REPORT SUMMARY MINOR VARIANCE APPLICATION FILE NUMBER A097/24

MINOR VARIANCE APPLICATION FILE NUMBER A097/24

CITY WARD #:	2
APPLICANT:	Lubov Zilyakov
AGENT:	Konstantin Alekseev
PROPERTY:	8326 Kipling Avenue, Woodbridge
ZONING DESIGNATION:	See below.
VAUGHAN OFFICIAL PLAN (2010) DESIGNATION:	Vaughan Official Plan 2010 ('VOP 2010'): "Low-Rise Mixed-Use" by Volume 2, Section 11.5 - Kipling Avenue Corridor Secondary Plan.
RELATED DEVELOPMENT APPLICATIONS:	None
PROPOSAL:	Relief from the Zoning By-law is being requested to permit a proposed secondary suite/dwelling unit onsite.

Private Residence

General Notes & Charts SITE PLAN

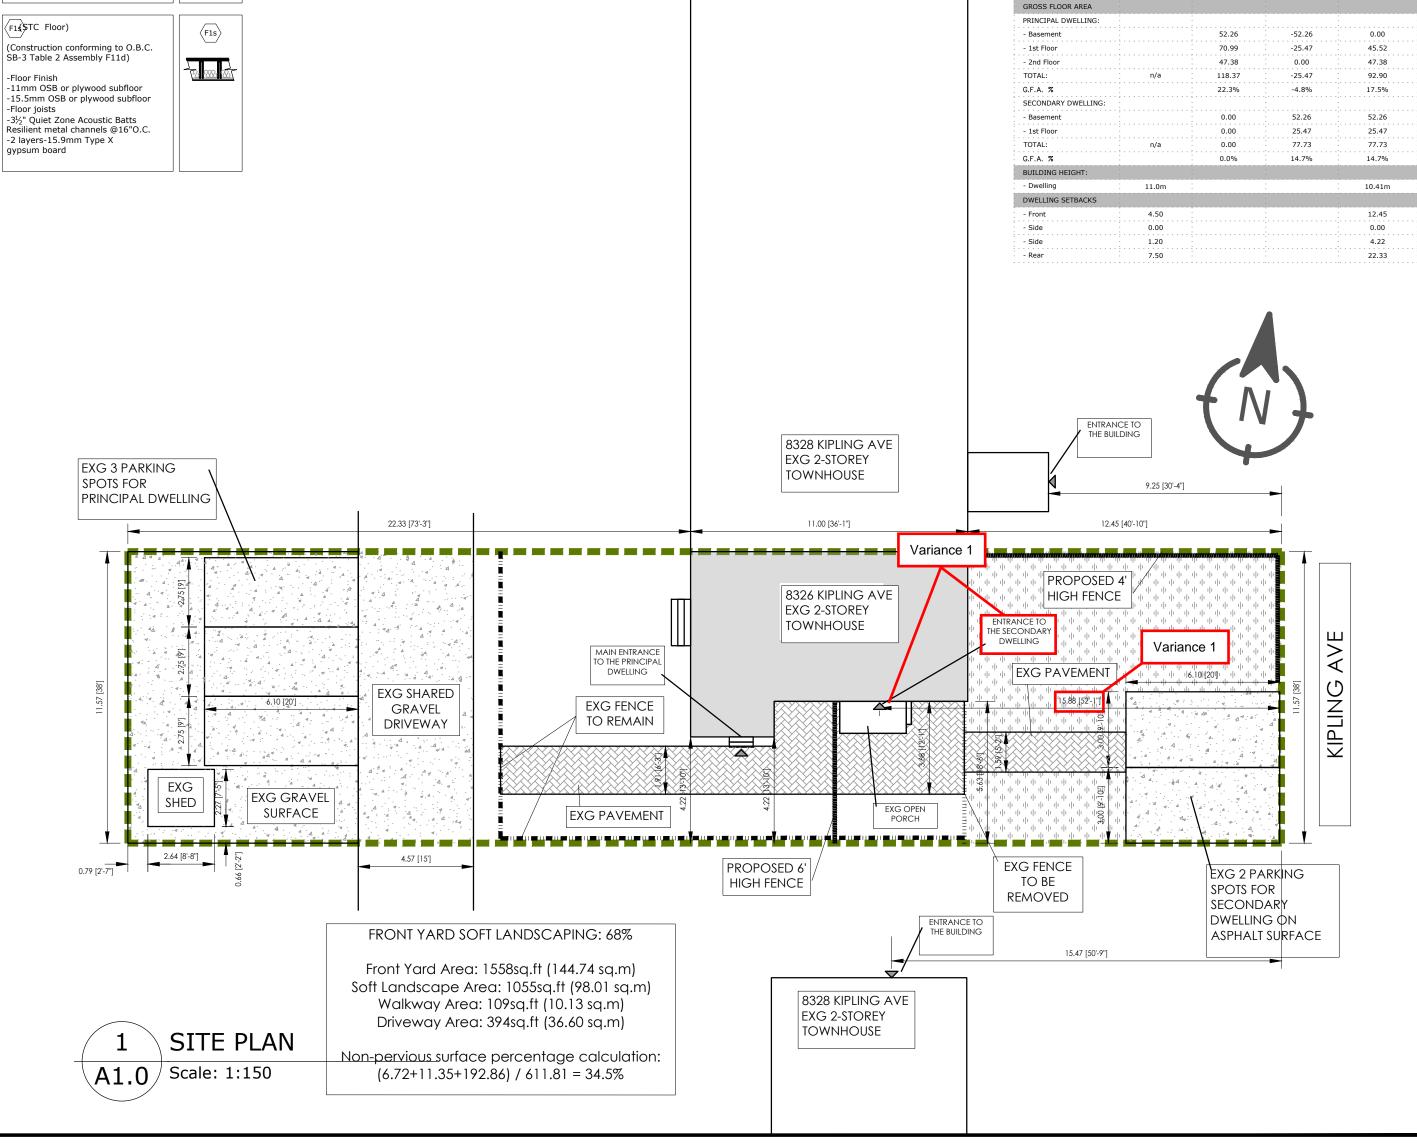
DEVELOPMENT ENGINEERING		
The state of the s	proposed entrance in the side yard. Development	
Development Engineering has reviewed the proposed entrance in the side yard. Development Engineering does not object to the Minor Variance application A097/24, subject to the following condition(s).		
Development Engineering Recommended Conditions of Approval:	The Owner/Applicant shall submit an application and obtain an approved Grading Permit before initiating any work on the property. The Final Lot Grading and/or Servicing Plan will be required for the Grading Permit Application. Please visit the Permits page of the City of Vaughan's website: Permits City of Vaughan to apply for a Grading Permit. For any inquiries regarding the Grading Permit, please email DEPermits@vaughan.ca

#	DEPARTMENT / AGENCY	CONDITION
1	Development Planning	TBC
	Nicholas.delprete@vaughan.ca	
2	Development Engineering	The Owner/Applicant shall submit an
	Rex.bondad@vaughan.ca	application and obtain an approved Grading
		Permit before initiating any work on the
		property. The Final Lot Grading and/or
		Servicing Plan will be required for the Grading
		Permit Application. Please visit the Permits
		page of the City of Vaughan's website: Permits
		City of Vaughan to apply for a Grading
		Permit. For any inquiries regarding the Grading
		Permit, please email DEPermits@vaughan.ca
